**PRE DEVELOPMENT APPLICATION ASSEST PROTECTION
ZONE/LANDSCAPING REPORT**

Reference No: Compliance DBKL2024-278

Site Address: 113 Orchard Street, Warriewood, NSW

Project: Infill Development – Construction of a new Dwelling

Figure 1. Detail of tree removal

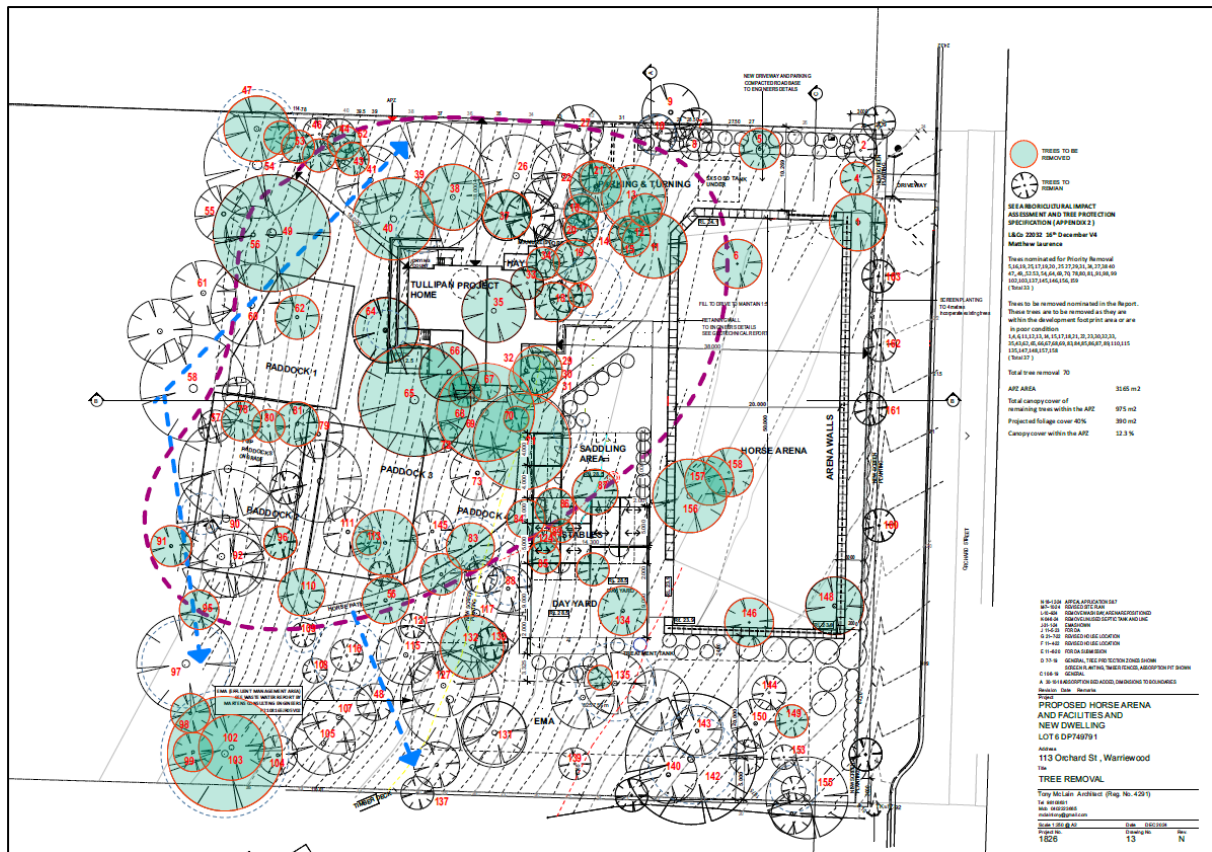
Notes as per Arborist and Ecological Services Recommendations: In my opinion these provisions are being followed as per the requirements of Appendix 4 of Planning for Bush Fire Protection 2019. The crown coverage estimated in the APZ is at 12.3%. This meets the IPA requirement of the PBP 2019 which says 'should be 15%' crown coverage. The arborist and ecologist have provided tree removal and Vegetation Management Plans (in perpetuity) to support the PBP 2019. These aforementioned documents embrace the requirements of the PBP 2019 with environmental and ecological planning, sustainability and sensibility that will nurture the requirements of the consent authority, NSW RFS, and planners with the client's needs, protection and survivability in the event of an extreme bushfire event.
